March 3, 2022

**RE: Draft Maine DEP Water Quality Certification for the Hiram Hydroelectric Project # L-07780-33-L-N, FERC Docket P-2530**

**Attachment B**

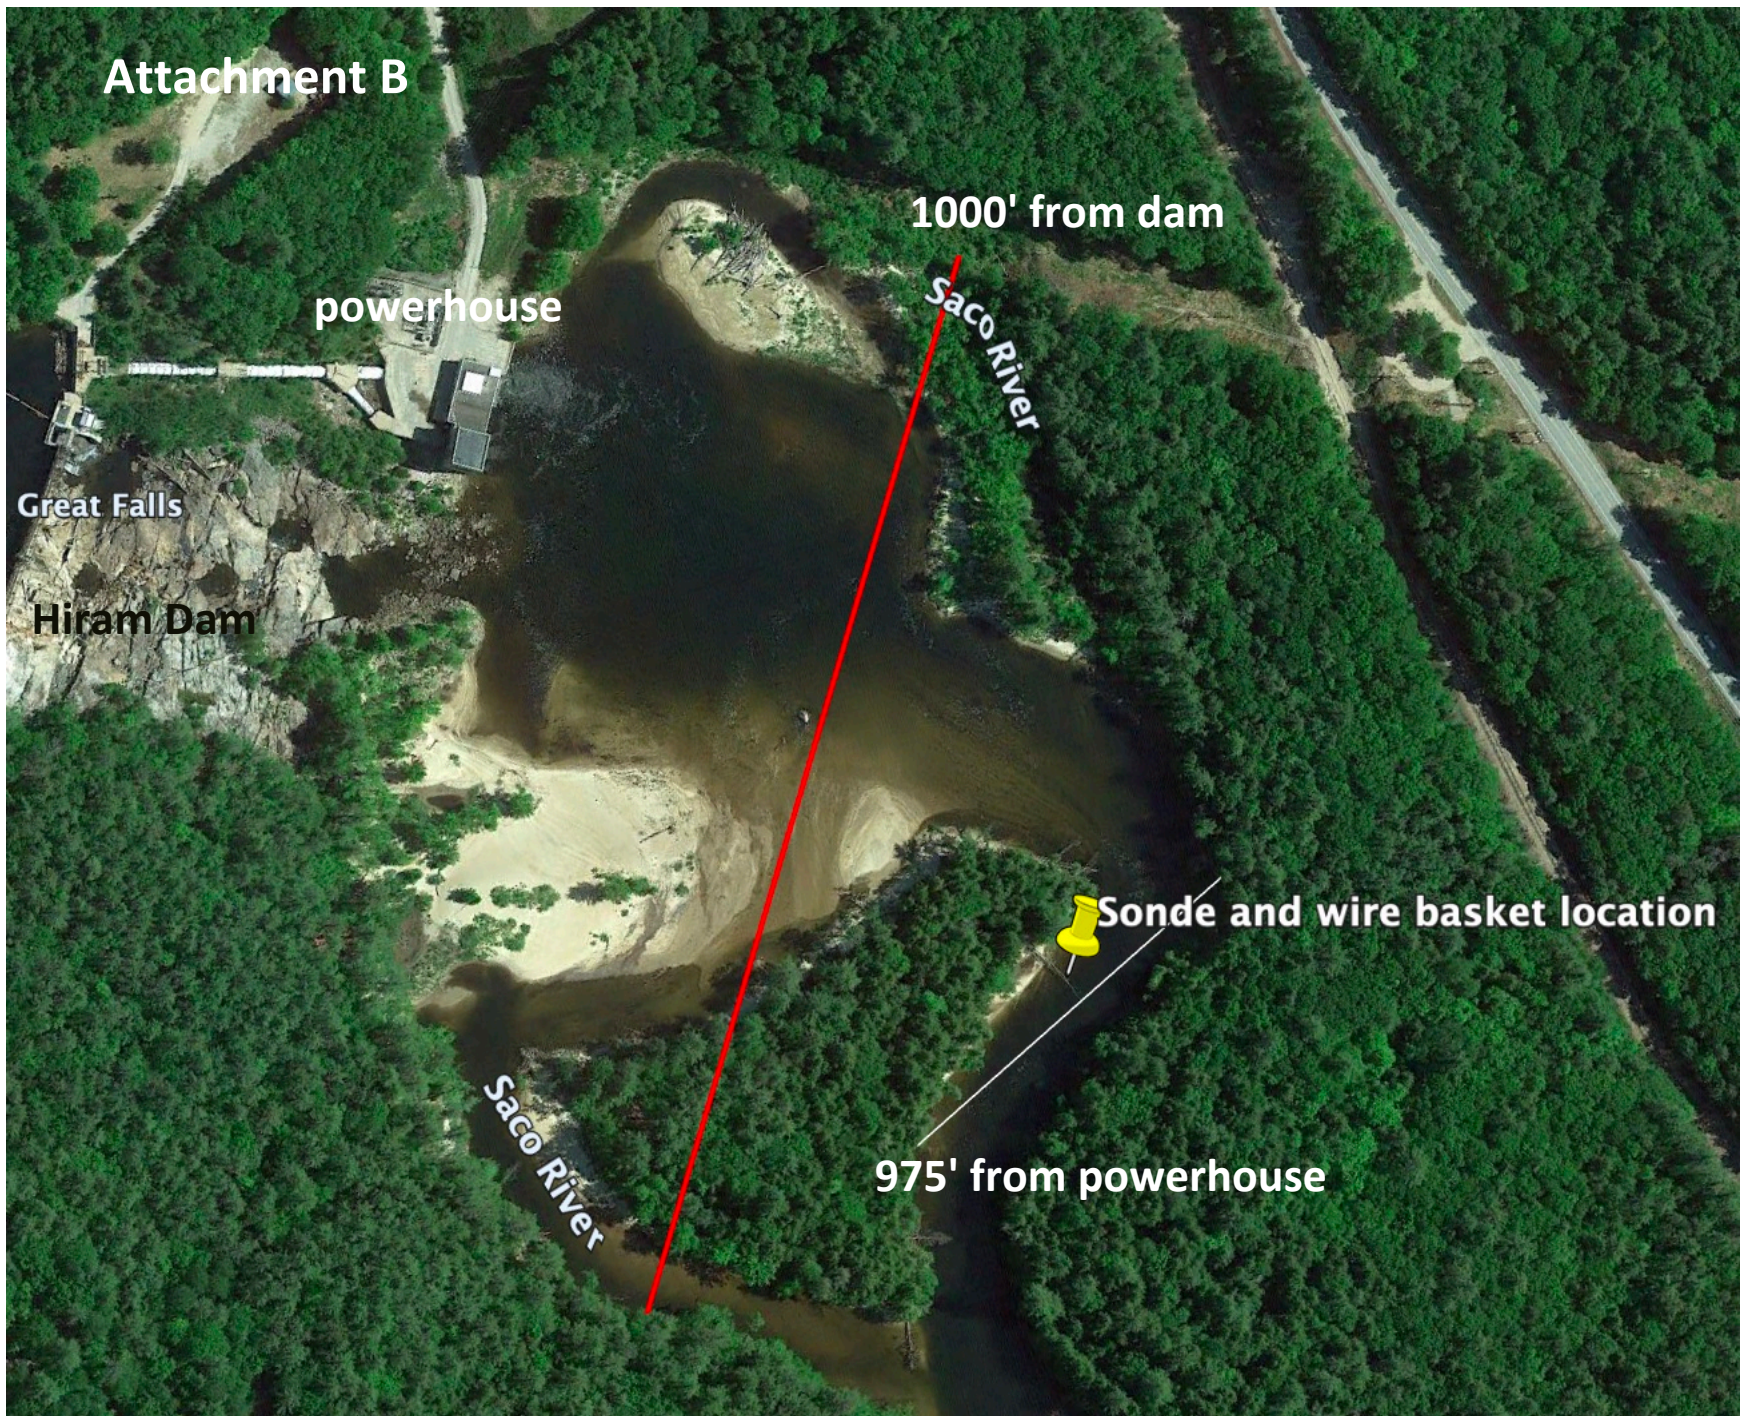
1000 feet below the base of Hiram dam - the Class A area - extends only to a point about 500 feet below the powerhouse. Thus, **975 feet downstream of the powerhouse is well beyond the Class A area and in the Class AA waters.** It is unclear whether the Applicant chose this location to sample to get a more favorable result or simply misinterpreted the plain language of the statute. In any event it appears to be in the wrong location. For clarification, we have provided Attachment B which illustrates the demarcation of Class A and AA waters relative to the Hiram Dam and powerhouse. In the absence of other interpretations, we must assume that the statute means what the plain language of the statute says: that the Class A waters extend from Hiram Dam itself, not the powerhouse.

DEP has established protocols for macro-invertebrate sampling<sup>21</sup> and we have included the key provisions as Attachment C. In its Foreword, the protocol document states: *"The Department has collected a large, standardized database consisting of benthic macroinvertebrate samples from above and below all significant licensed discharges in the State, from areas impacted by non-point sources, as well as from relatively unperturbed areas. These sampling locations were chosen to represent the range of water quality conditions in the State."*<sup>22</sup> Apparently, although extensive, the sampling locations were not all inclusive. None of the sampling devices seems reasonably applicable to the Hiram Project: Rock-filled wire baskets are for *"wadeable [sic] rivers"* and *rock-filled mesh bags* for *"small flowing streams"*<sup>23</sup> and the Saco, Maine's fourth largest river, is clearly neither; boats were used for the fish assemblage study for a good reason. **Cones could, however, have been deployed into the deeper water in the Class A area.**

**Photo 2.1-2: Location of datasonde downstream of Hiram Project**

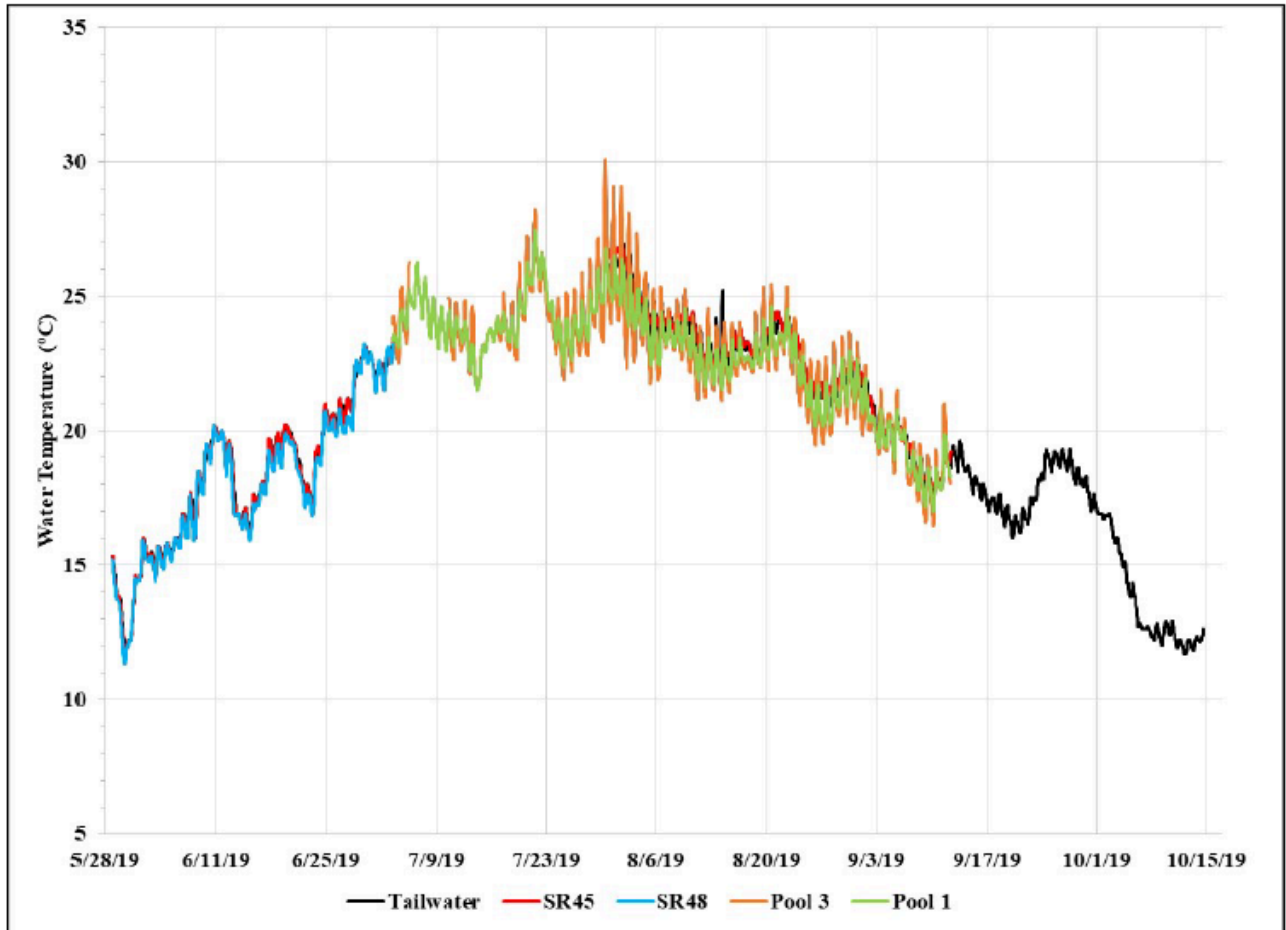
This clearly defines the area of primary concern to be entirely in the plunge pool located below the powerhouse per Attachment D.<sup>25</sup> Water with similar characteristics should have been the site of evaluation, yet instead of sampling in the plunge pool, the data submitted was in waters on a point of land below it with different characteristics on a much narrower run of water. Scrutinizing the protocols, we found that sampler placement is to: **“Avoid bank effects: samplers should be located in the middle 50% of the bank to bank width, or in an area with a flow regiment typical of the overall character of the stream segment.”<sup>26</sup>** (Emphasis supplied) Attachment D also shows that the sampler was placed near the bank. Of additional note: we also discovered during our analysis that the field data sheet submitted for the macro-invertebrate study<sup>27</sup> provided as Attachment E shows the following Lat-Long Coordinates: 43° 39'52.49"N, 70° 36'03.27"W. This locates the samplers below the West Buxton Dam. While this makes exact location of the sampler impossible to determine, the Attachment F photograph<sup>28</sup> confirms that the Sonde was next to the west bank.

Please note that: *“Rooted aquatic grasses were present at the sample site and the substrates were covered with filamentous algae.”<sup>29</sup>* This indicates that the sample site, located outside the Class A waters, was not only dissimilar from the Class A waters of primary interest but from the river section as a whole. The sampling site was located on an inside bend where currents are slower. Speaking with a local resident, the far bank from where the mesh bag samplers were deployed is deeper, as is normally the case with outside bends as currents are stronger there. The water on that bank should bear a greater resemblance to the Class A waters below the powerhouse. It was also reported that most of that section of the river does not support the algal growth described in verbiage and shown by photographs in the ISR. **While such algal growth is often present on the edges of streams, it is more consistent with slack water areas the protocol cautions to avoid.**<sup>30</sup> It does not normally appear in the deeper waters with more current that detaches filamentous algae. Current is also diminished at this location as some water passes through the back channel to the west to rejoin the flow below the sampling site.

**FIGURE 4-7 WATER TEMPERATURE FROM THE HIRAM IMPOUNDMENT AND TAILWATER AND THE HIRAM FALLS REACH, MAY 28 TO OCTOBER 14, 2019**

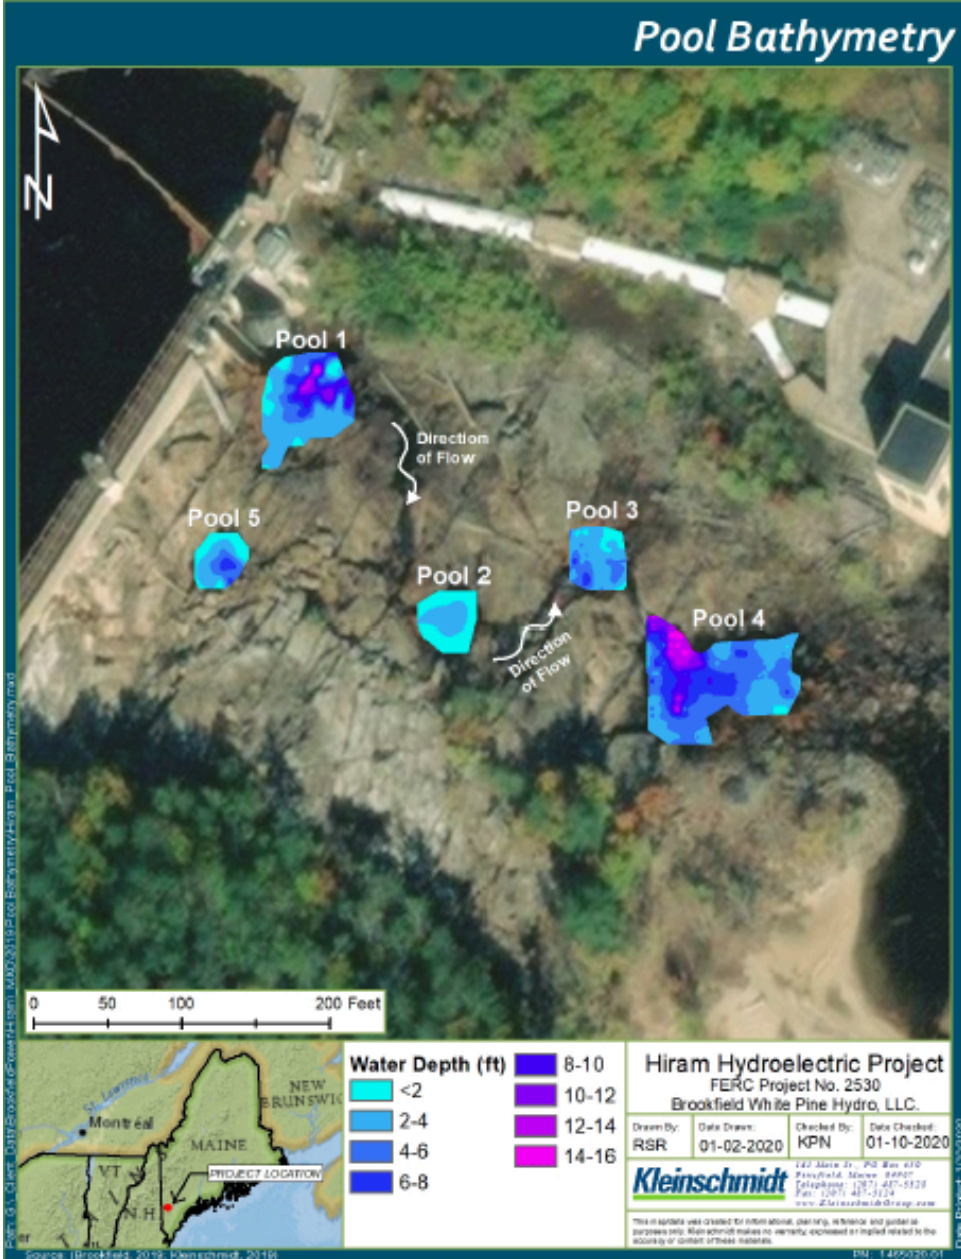
That having been said, DO levels reported in Initial Study Report.<sup>36</sup> did not meet DO levels on at least five occasions. The FLA notes this is because of “*impoundment effect*.”<sup>37</sup> Attachment G<sup>38</sup> shows water temperatures taken at different locations in the impoundment, the by-pass and the tailwater. Please note that while it is difficult to see from the graph, the temperatures in Pool 3 vary to a much greater degree than temperatures from the other locations. This is not due to impoundment effect but to the effects of so much bare rock interacting with a trickle of water: we have dubbed this the ‘much rock, little water’ effect. If this were not the case, Pool 1, the upper pool, would show the greatest variations. Please also note that it is impossible from the graph to determine if rises in tailwater temperatures correlate with impoundment temperatures. The data either is not graphed or is hidden behind other data. Please additionally note the discrepancy between pool numbers in the verbiage and the legend of the graph: Pool 2 in the verbiage, Pool 3 in the legend of the graph. It is therefore not possible to conclude from the data that the “*impoundment effect*” is responsible for the failures documented.

Photo 4 , west side 2 - description on following page.

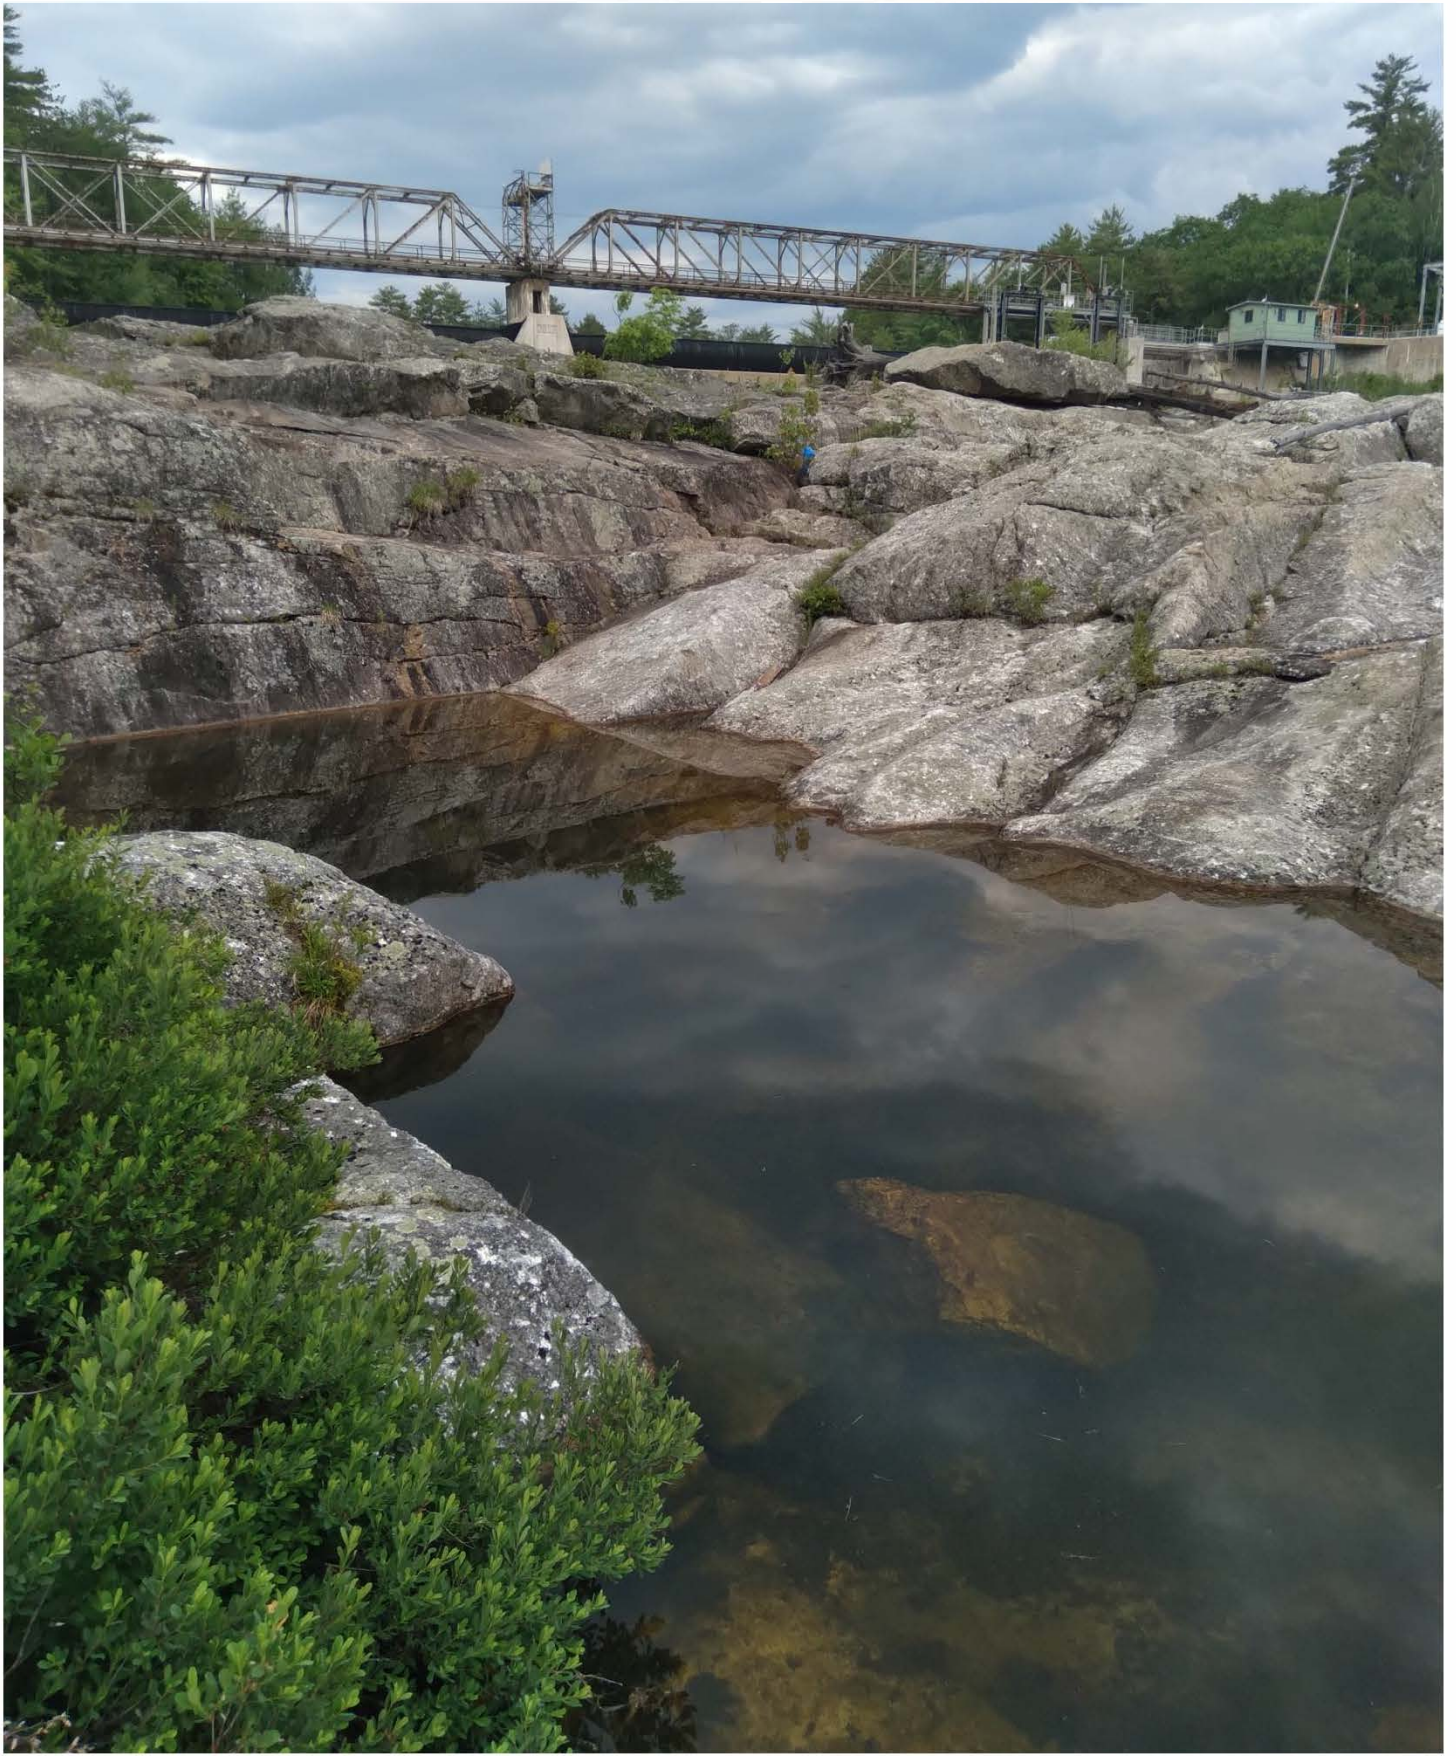
There is value in the dewatered reach below Hiram Dam that is being minimized and ignored by the Draft Water Quality Certifications. On June 8, 2021, Sebago TU Conservation Committee member Matt Streeter visited the Hiram Dam site in order to photograph conditions. Some of these photos have been attached, along with detailed descriptions, as Attachment I. The photos demonstrate the following:

- 1) That the grade of this 500-foot section of river is moderate, walkable, fishable, and passable by most fish species.
- 2) That the east side of the cascade, where high velocity flows from dam releases are concentrated, is scoured of all sediment and plant life, giving the impression that aquatic life is not sustainable.

- 3) That by contrast, the west side of the cascade, spared the damage caused by dam releases, sustains basic aquatic plant and animal life and riparian vegetation, which could be a great deal more varied and abundant if minimum flows were directed over the full width of the dam, and high velocity flows from gate releases were kept to a minimum.

Photos 3 & 4, West side 1, West side 2 (above): These photos are characteristic of the west side of the cascade, which is not subjected to the concentrated flows of dam releases. Though dewatered, the pockets in this section at the time these photos were taken contained water and retained aquatic plant and animal life including algae, aquatic insects and tadpoles. Sand and gravel is abundant, and riparian plant species are present. As on the east side, the grade is moderate and with a modest flow would be passable by most fish species. This is attested by the comments of Bruce McLaughlin (Attachment L), a fisherman who fished this section of cascades from its base to the toe of the dam on a regular basis from the early 1980's through 2008. According to McLaughlin, "At that time, there was a fair amount of water flowing over the entire dam". Along with many other fishermen and women for whom Hiram Falls was a destination fishing spot at the time, he "fished all of the pools, starting at the upper ones just below the dam. There we caught decent sized brook trout, and as you descended the rock face to the lower pools and area across from the power house we caught pickerel, fallfish, brown trout, eels and bass". Even in the photos of this dewatered section, any fisherman or woman would recognize that this would be an abundantly populated section of river if it were not dewatered 85 percent of the time.
